Addendum Number: 1

Addendum Issue Date: April 28, 2022

Project Name: Springdale Creek Streambank Stabilization

Project Number: 018158.145

Photos of example J Hooks (1 page)

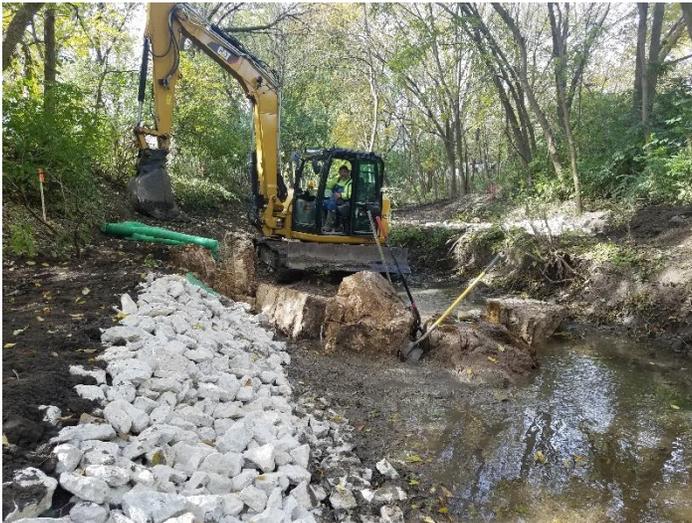
- 4) Question: Could stone larger than 36" diameter be used for the footer stone shown in the J Hook detail.
Answer: Yes, if necessary.
- 5) Question: Could a photo of an installed J-Hook weir be provided.

Answer: Yes, example photos will be provided in the Addendum.
